MARTIN COUNTY, FLORIDA DEVELOPMENT REVIEW

STAFF REPORT

ISLAND CROSSINGS (F/K/A ROSCOMMON SQUARE) PUD SIXTH PUD AMENDMENT WITH REVISED MASTER SITE PLAN AND OUTPARCEL A FINAL SITE PLAN (A/K/A BRIDGE ROAD SELF STORAGE)

Attachment I – Previously Approved Master Site Plan (3rd PUD Amendment)

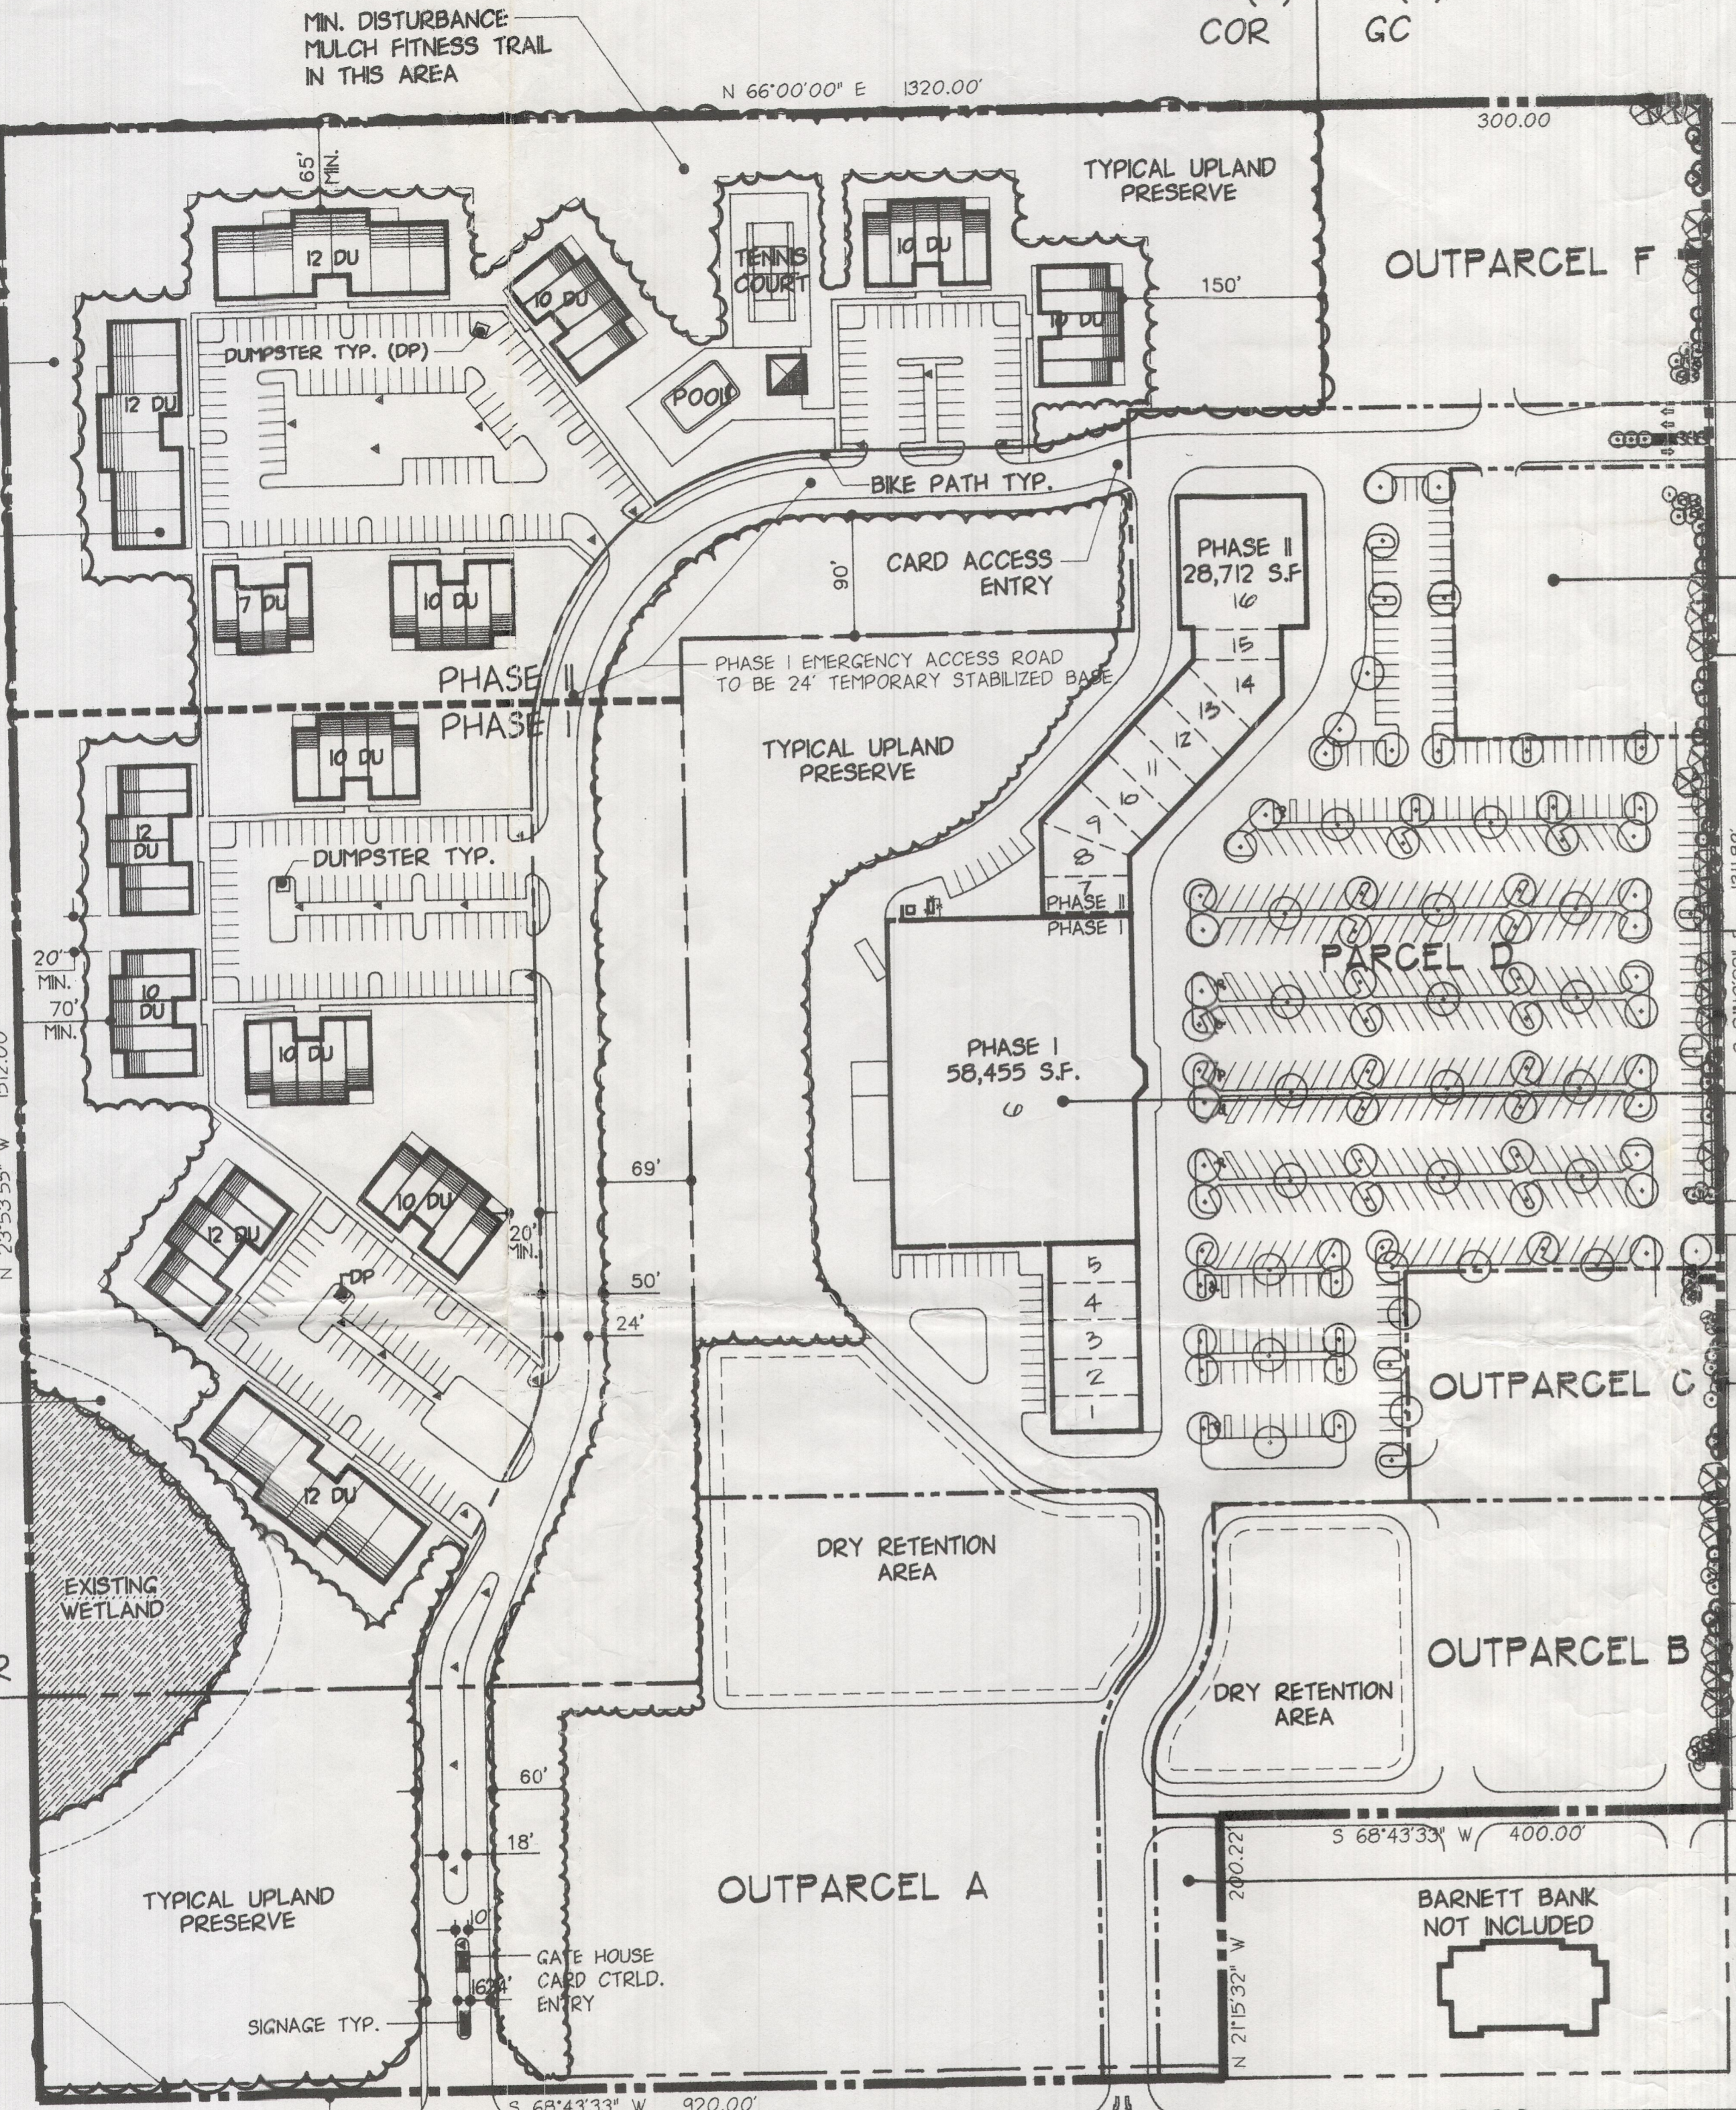
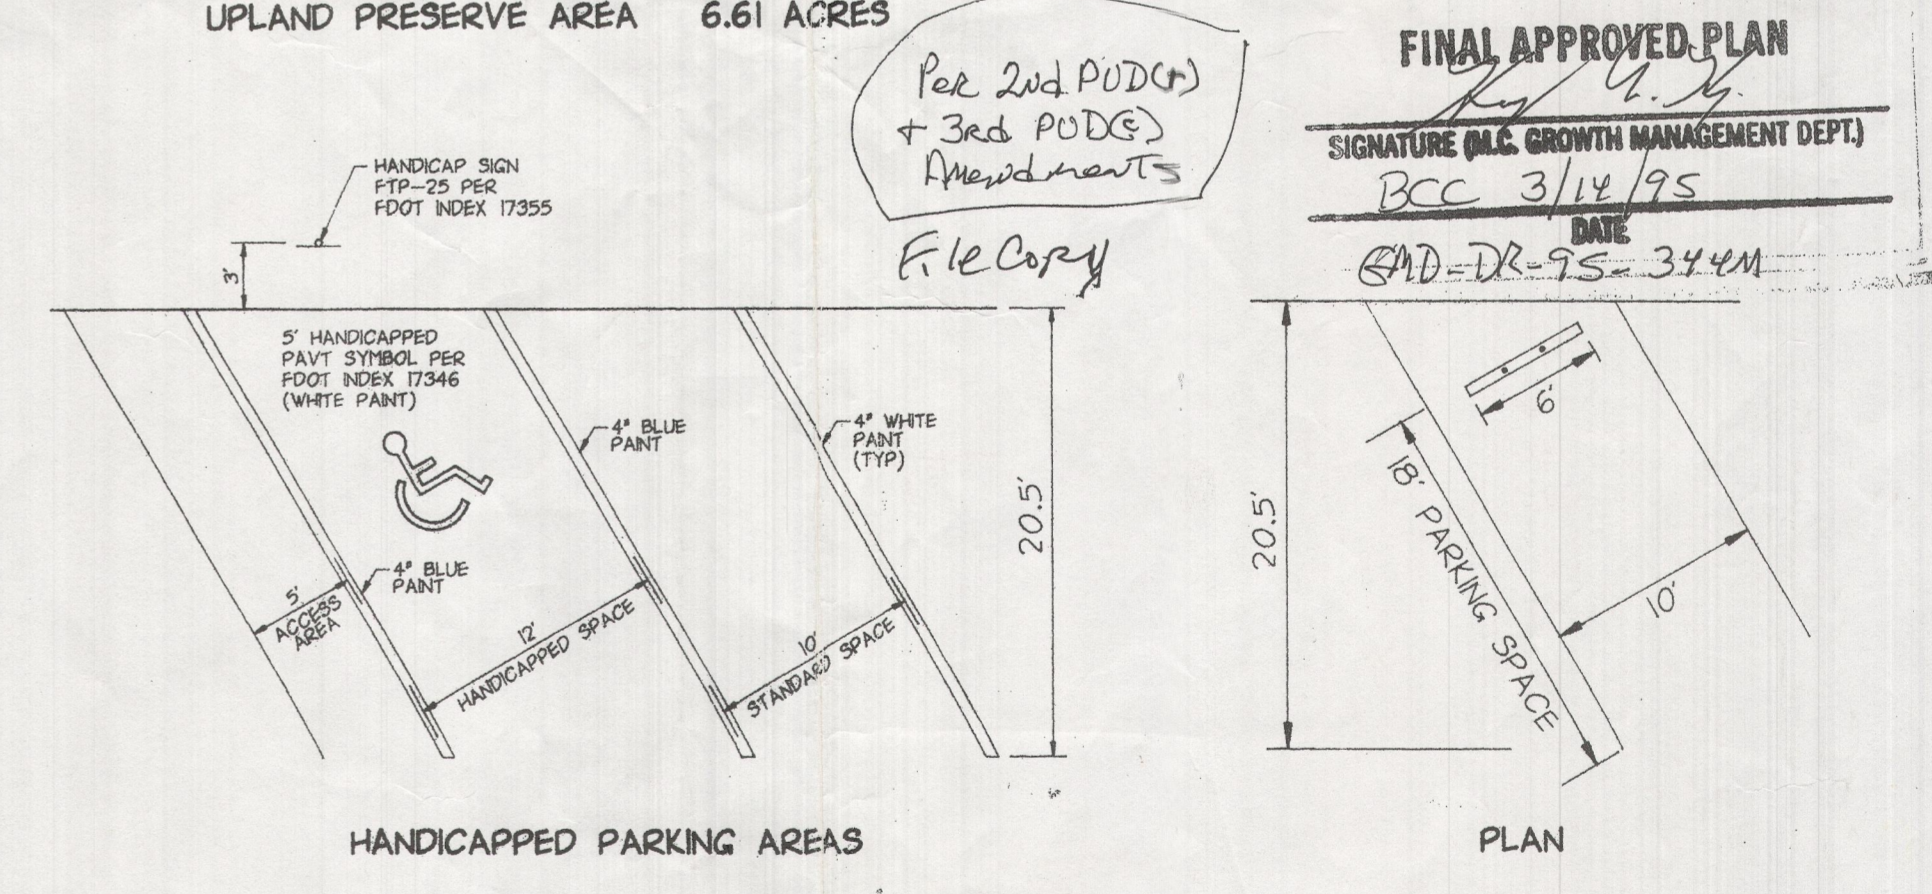
1. Please provide a revised master site plan showing the extent of the Island Crossings PUD-C, please refer to the most recent revised master site plan that was approved as part of the 3rd PUD Amendment. A higher resolution copy of the most recent revised master is included in Section Z of this report. The revised master site plan should reflect the separation of the western residential portion from the commercial portion and also needs to reflect any changes contained within the text of the proposed amendment (i.e., increase in total building square footage, addition of permitted use, etc.).
